#### NPA/25/35

**Title of Proposal:** Quinquenial Review **RA(s) or Manual Chapter(s):** RA 3517

### **RA 3517 - Permanent Fixed Wing Aerodrome - Markers**

Figure 1. Boundary Marker Dimensions

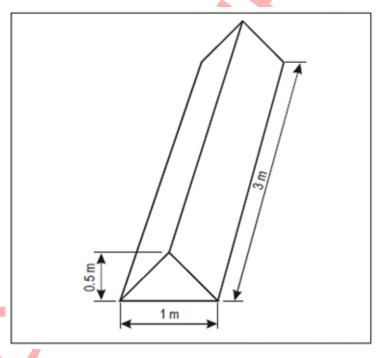
- RA 3517(7): Changes to wording to ensure clarity of requirement to use the markers being discussed.
- RA 3517(8): Insertion of wording to ensure clarity of requirement to use the markers being discussed. | Para 27 ammended to aid clarity.

26. A single colour, orange or red ▶may be used; ◀ or two contrasting colours ▶of ◀ orange and white. ▶ ◀ Alternatively red and white may be used, except where such colours merge with the background.
